**Re: Request for Appeal and Agenda Placement, October 15, 2025 Planning Board Meeting**

Eastern Development, LLC respectfully requests that this appeal be placed on the Planning Board's October 2025 agenda. The appeal seeks modification of conditions imposed on the final approval of the above-referenced project relating to:

# Granite Ridge Estates Cluster Subdivision

### TYPICAL ROADWAY CROSS SECTION

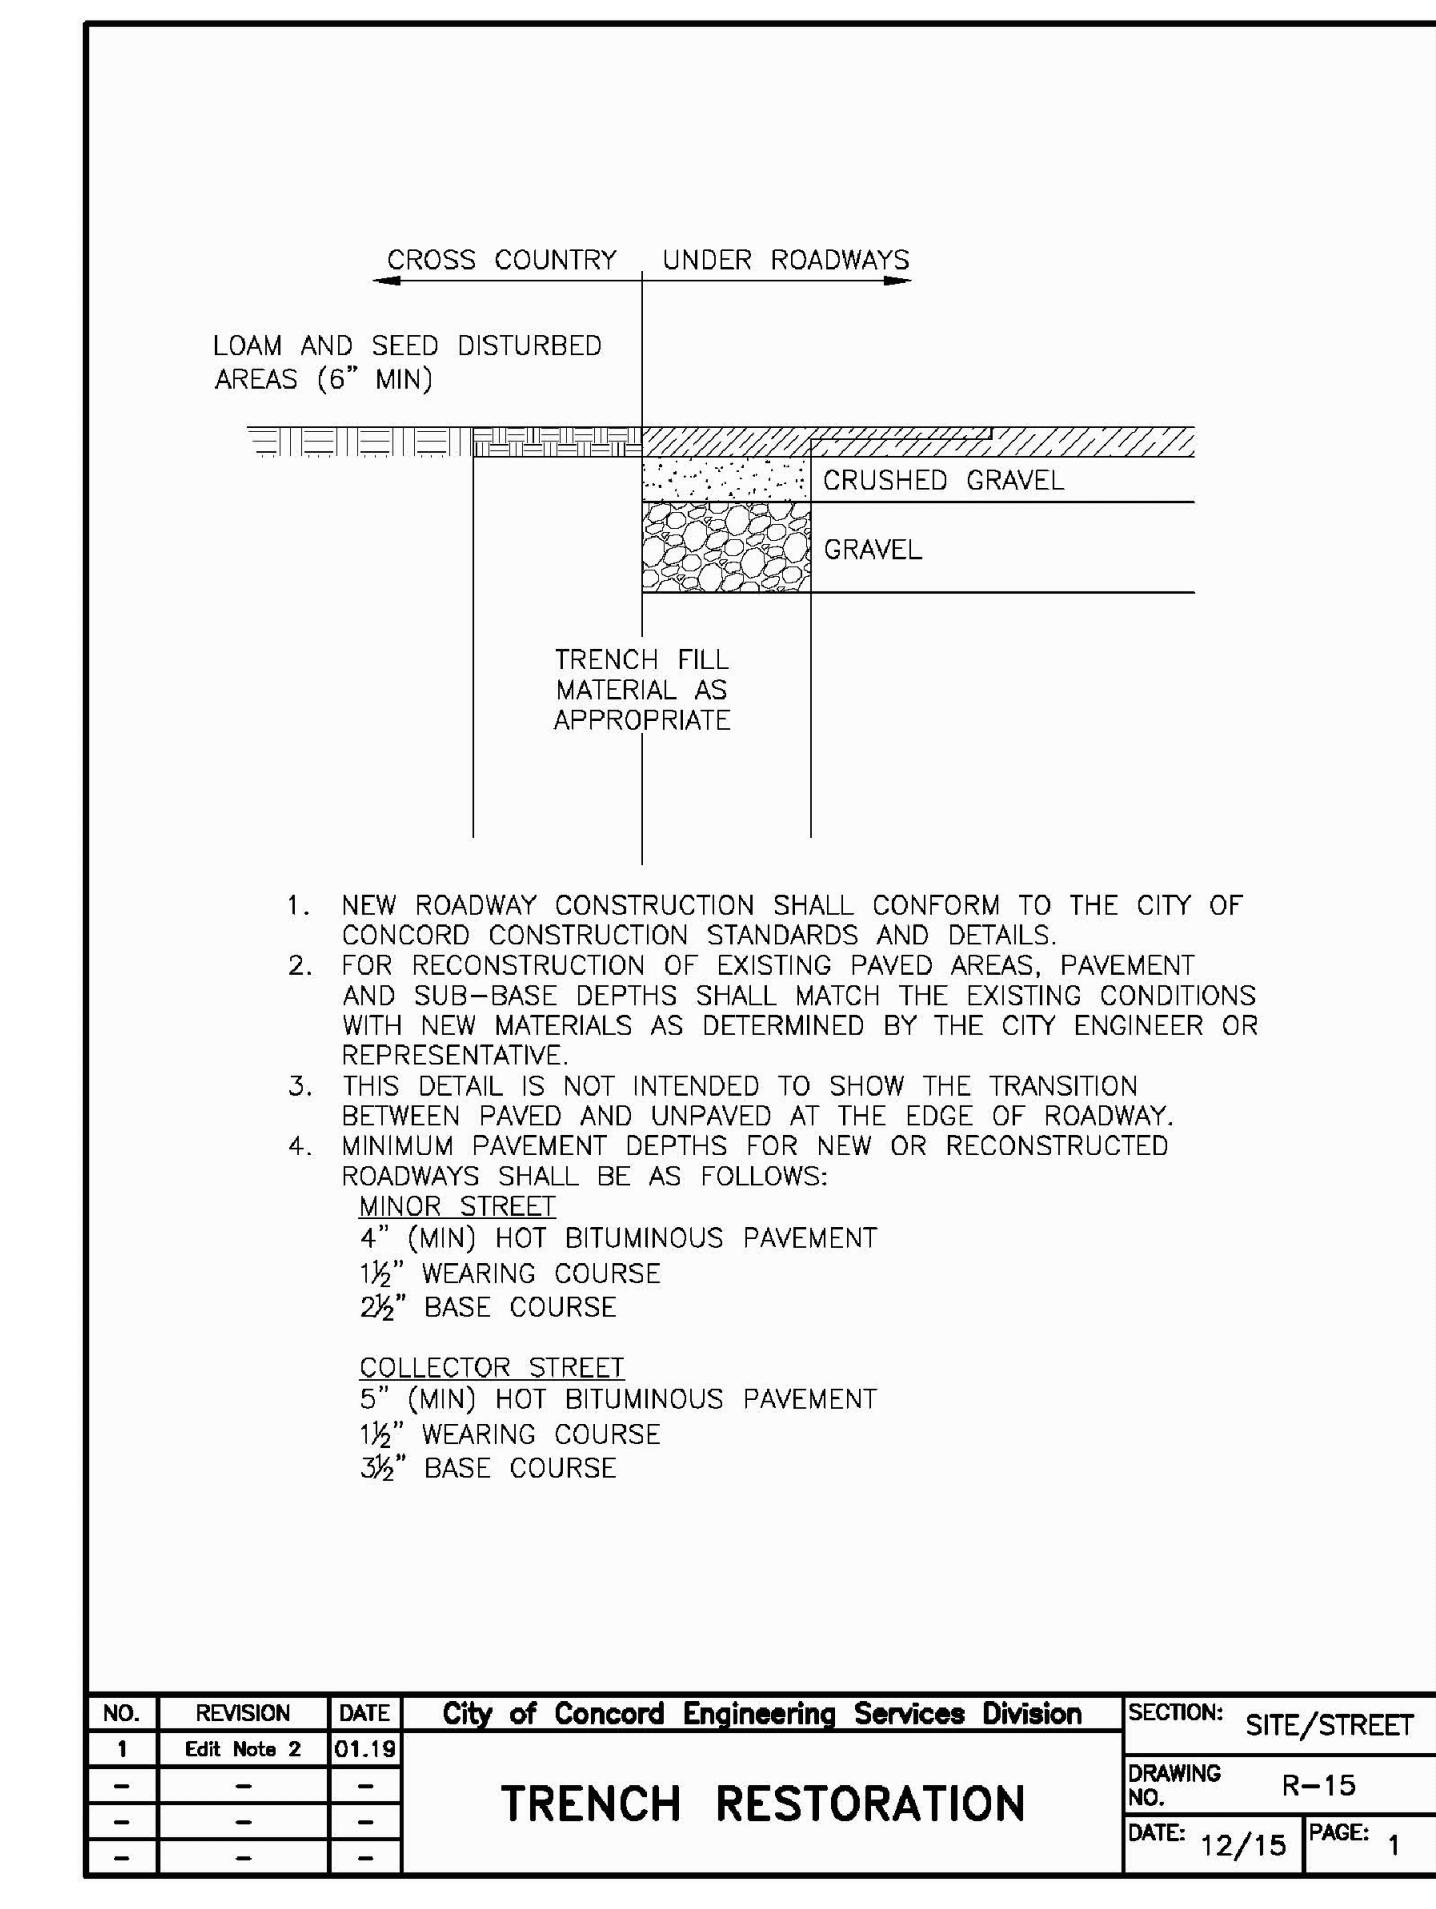
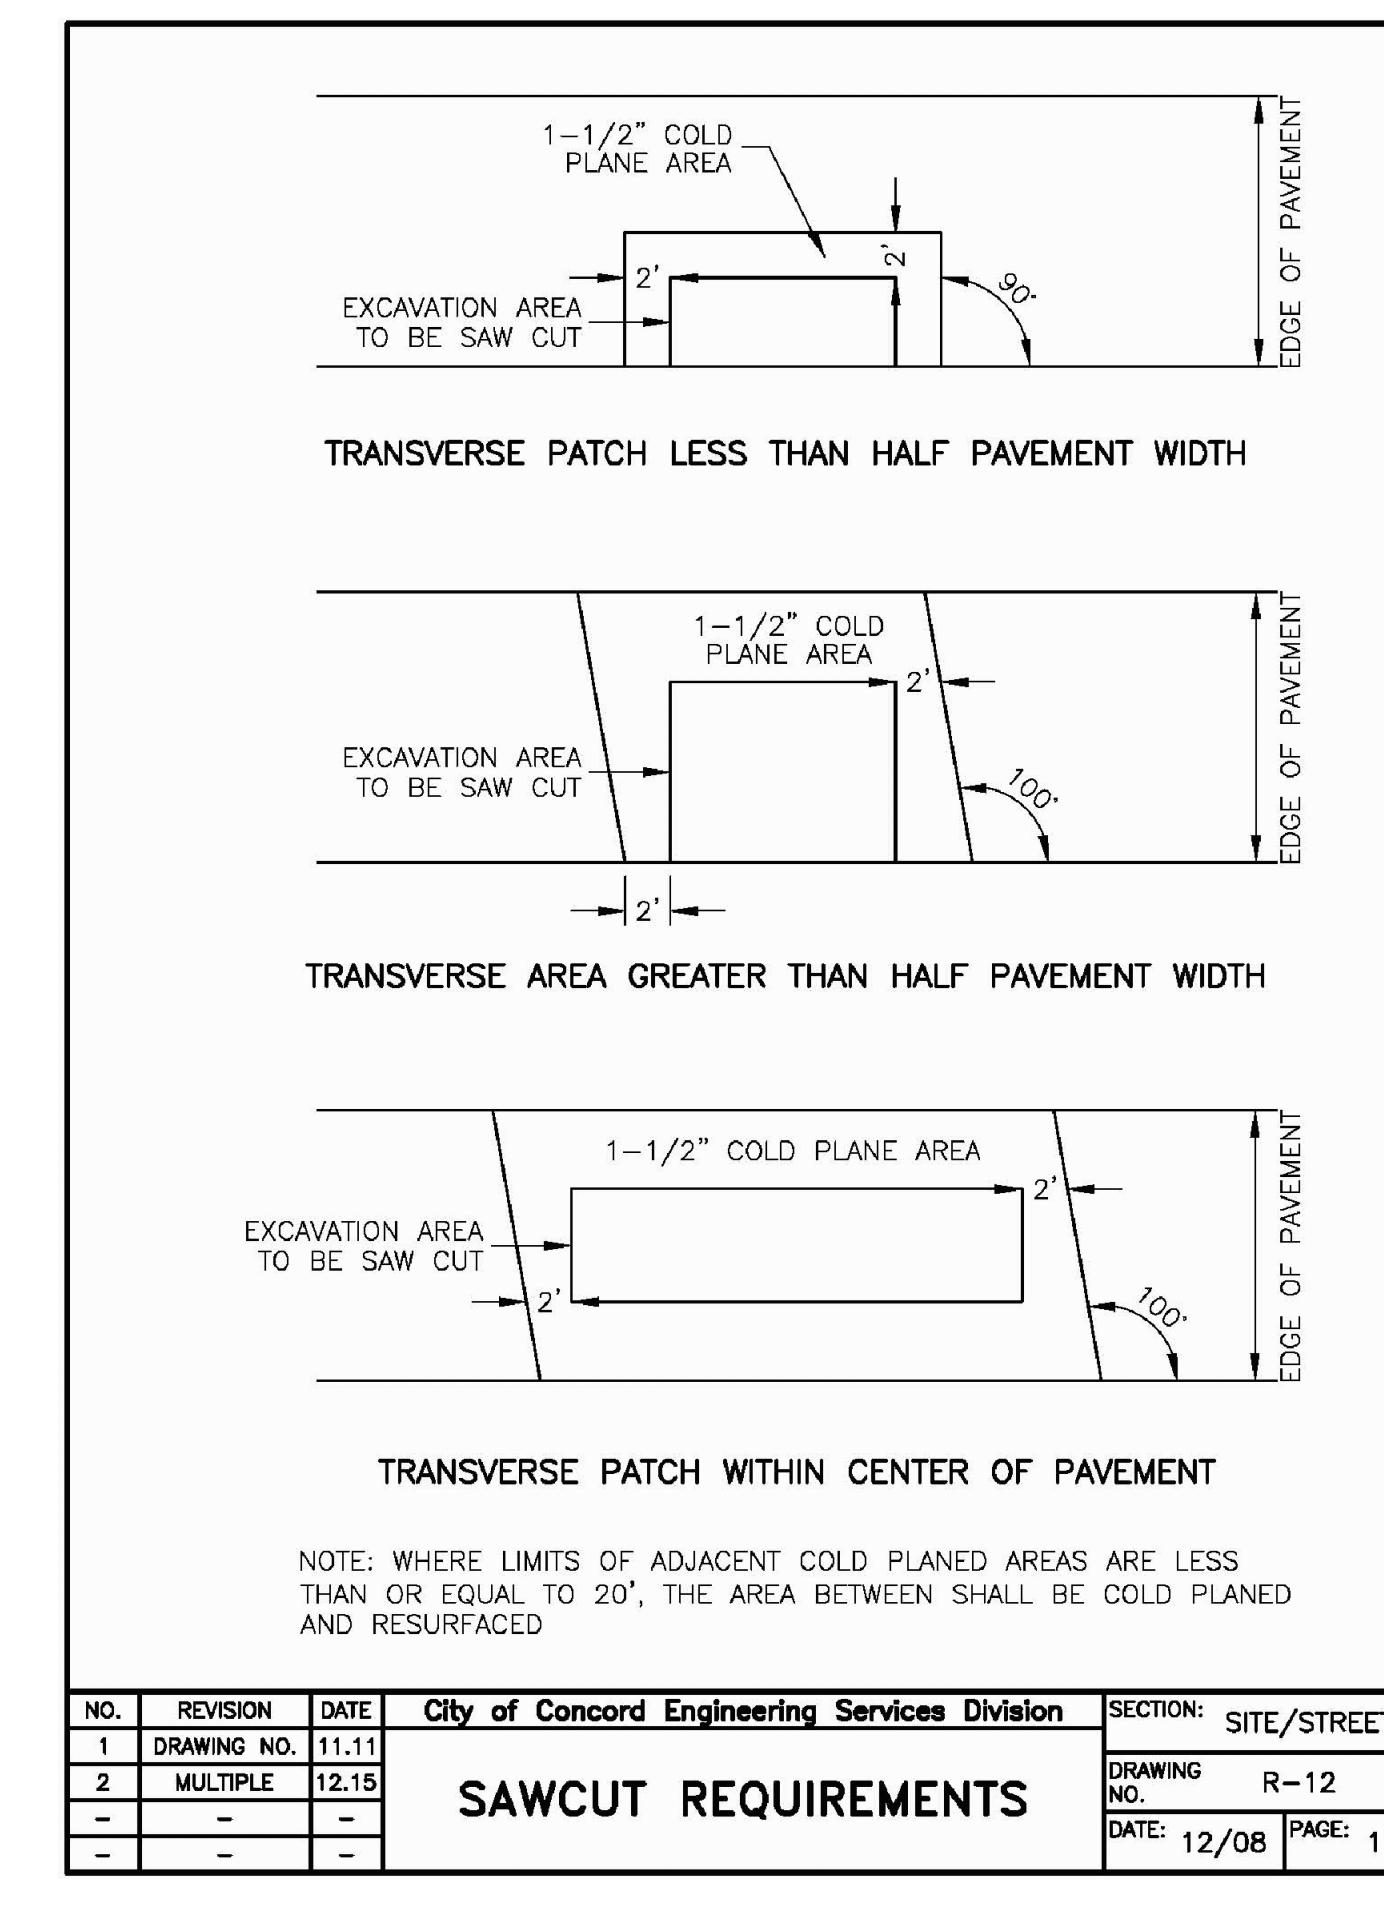
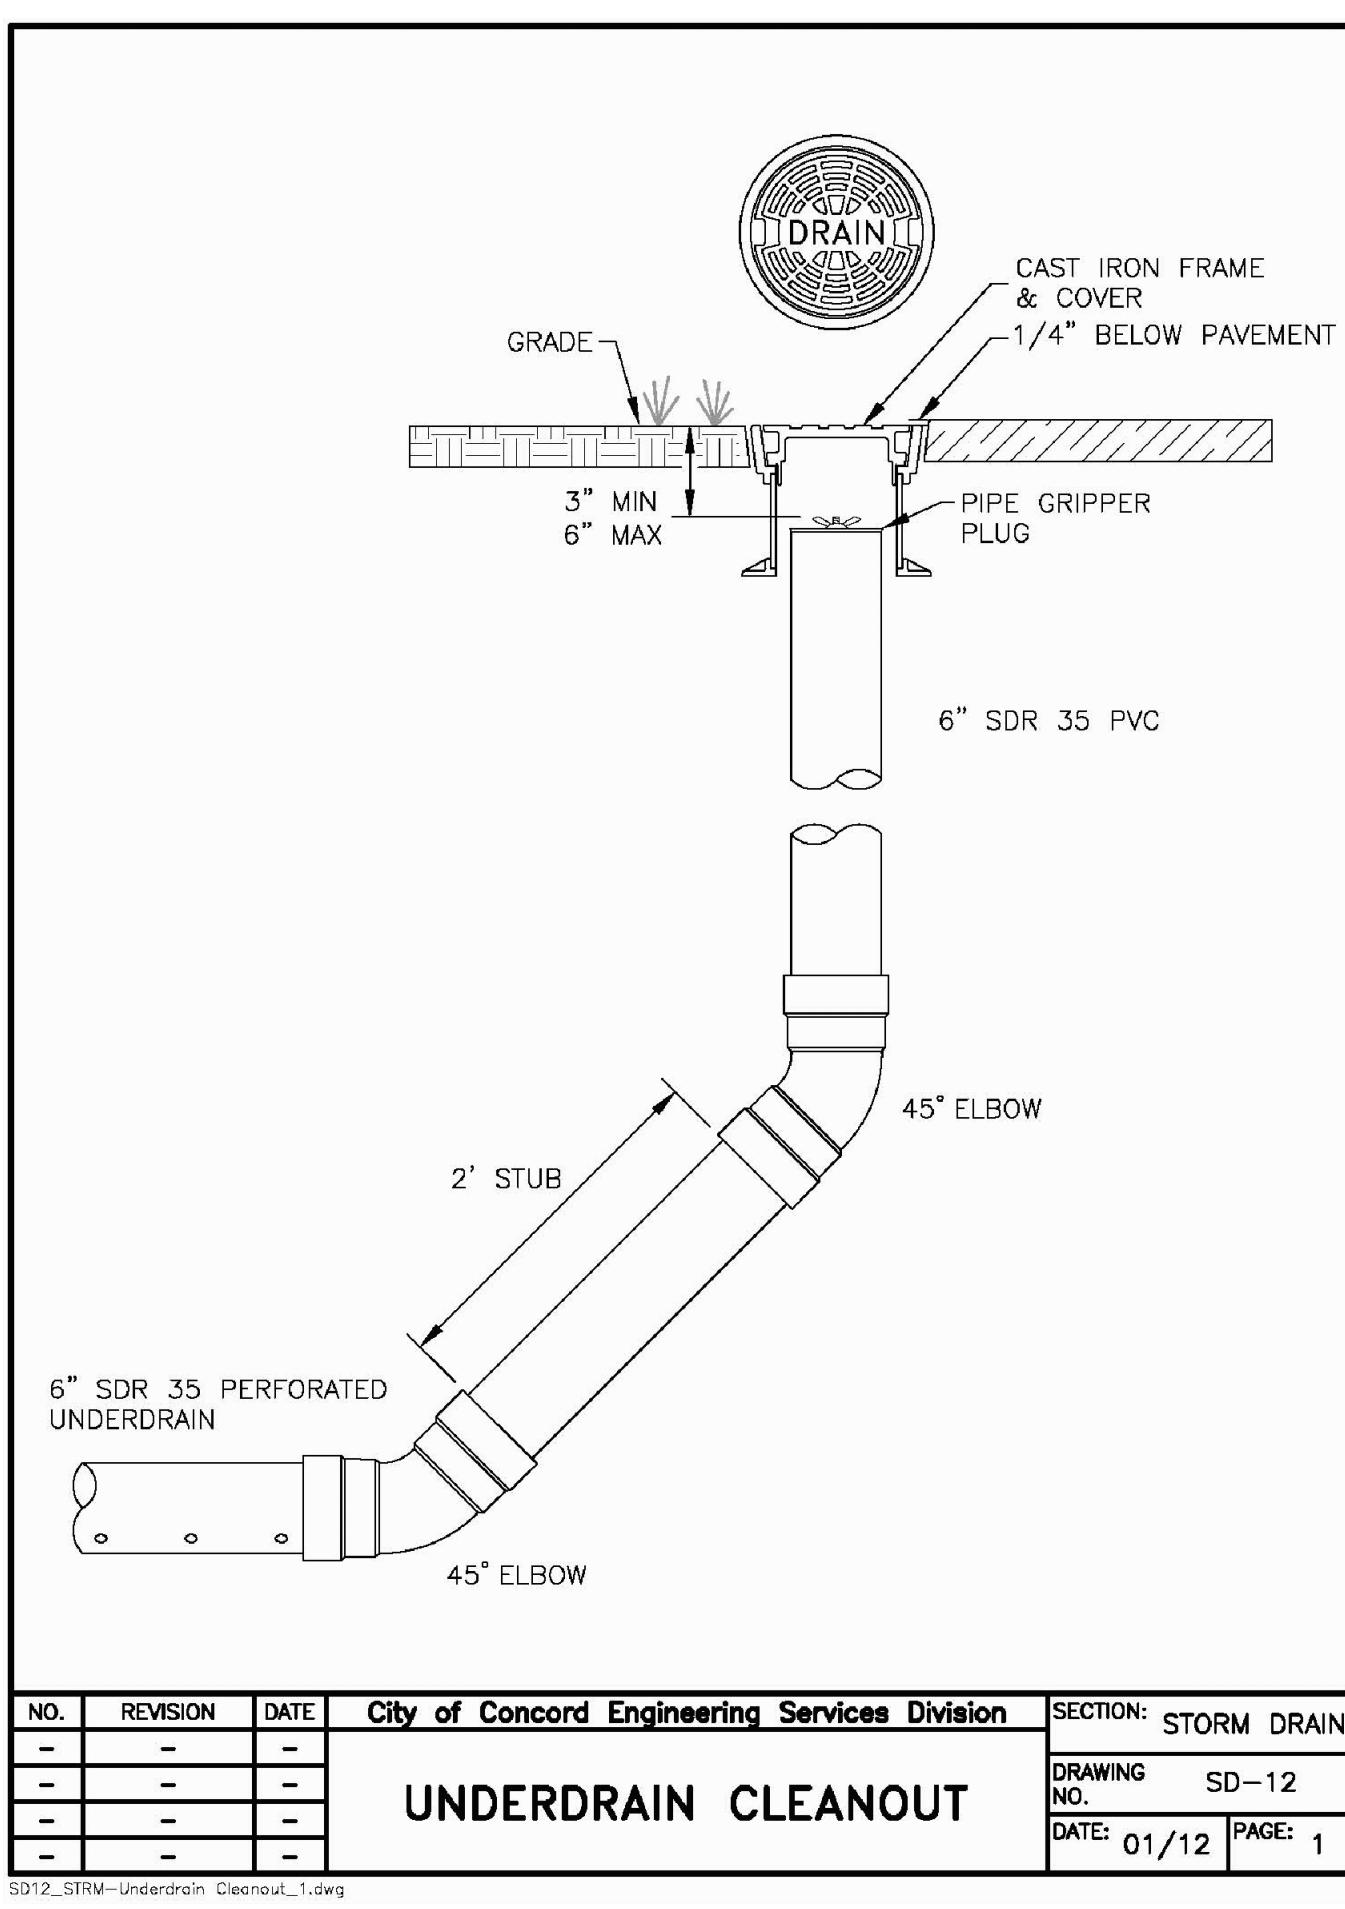
## 4. Pavement Thickness: Code, Standards, and Engineering Basis

Concord’s Subdivision Regulations 21.05 state: “*Common private drives shall be surfaced with a minimum of three (3) inches of hot bituminous pavement per State specifications.*” The project

proposes exactly that standard, 1.5" binder and 1.5" wearing course, compacted to 3 inches total, consistent with NHDOT Section 401 Plant-Mixed Pavements, which Concord expressly references. The city's 2020 Construction Standards & Details also specify for driveways a section of 6" crushed gravel plus 3" hot bituminous pavement in two lifts, aligning with 21.05's minimum requirement for common private drives.

At the May 15, 2024, meeting, the city objected to the 3" pavement thickness but did not present factual evidence or engineering data. The minutes reflect:

- An acknowledged inconsistency between the Subdivision Regulations (3") and a Construction Standards detail (4").
- The city Engineer's statement that 3" is the state minimum standard for rural residential roads and sufficient for low-volume facilities.
- Staff noted they intended to "fix" the verbiage to require 4" in the future, but no such amendment had been adopted.
- Several Board members recognized that 3" was acceptable and that any inconsistency would not affect the city, since the roadway is private and HOA-maintained.

Neither Concord nor NHDOT has produced findings that 4" performs materially better than 3" for private, low-volume roads. Absent unusual conditions (heavy truck use, poor soils, drainage issues), there is no engineering or legal justification for exceeding the codified 3" minimum.

**Requested Action:** Approve the project's 3" compacted HBP pavement section as compliant with:

- Concord Subdivision Regulations 21.05 (minimum 3" requirement),
- NHDOT Section 401 (state standard).
